Docket Item # 4  
BAR CASE #2008-0128

BAR Meeting  
September 3, 2008

**ISSUE:** Alterations  
**APPLICANT:** Joel and Kelly Abramson  
**LOCATION:** 602 South Lee Street  
**ZONE:** RM/Townhouse zone

The applicant is requesting approval of a Certificate of Appropriateness for replacement windows at 602 South Lee Street.

Figure 3. Proposed window specifications for Marvin Ultimate double-hung, simulated divided light, all wood windows.

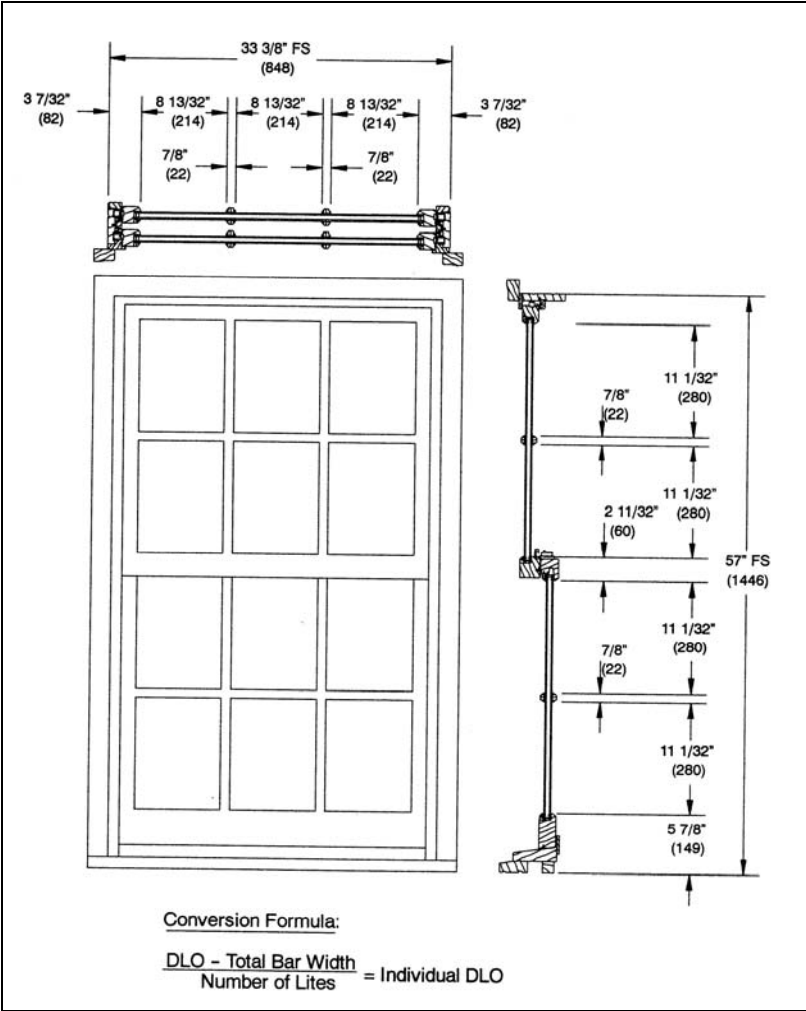
The existing windows are single-glazed, six-over-six wood windows with exterior storm windows. These windows are in a deteriorated condition. The applicant is requesting approval of Marvin Ultimate Double Hung all wood windows with a six-over-six configuration. The windows will be double insulated with simulated divided lights and an interior spacer bar. The muntins will measure 7/8". The proposed windows will replicate the existing windows with the exception that they will be simulated divided light with a spacer bar instead of true divided light and double-insulated instead of single-glazed.

The *Design Guidelines* recommend that: "...replacement windows should be appropriate to the historic period of the architectural style of the building." The *Guidelines* also state that single-glazed, true divided light windows with interior storm sash are the preferred replacement window type. The *Guidelines* continue by saying other acceptable window types are "double-glazed true divided light wood windows...Windows with fixed or applied muntins have been approved for the rear elevation of a structure which has minimal visibility from a public right of way." In this particular case, given the age of the townhouse and the fact that the existing six-over-six light configuration and 7/8" muntin profile will be retained, Staff does not object to the installation of double-insulated replacement windows with simulated divided lights and spacer bars.

**IV. STAFF RECOMMENDATION:** Staff recommends approval of the application as submitted.
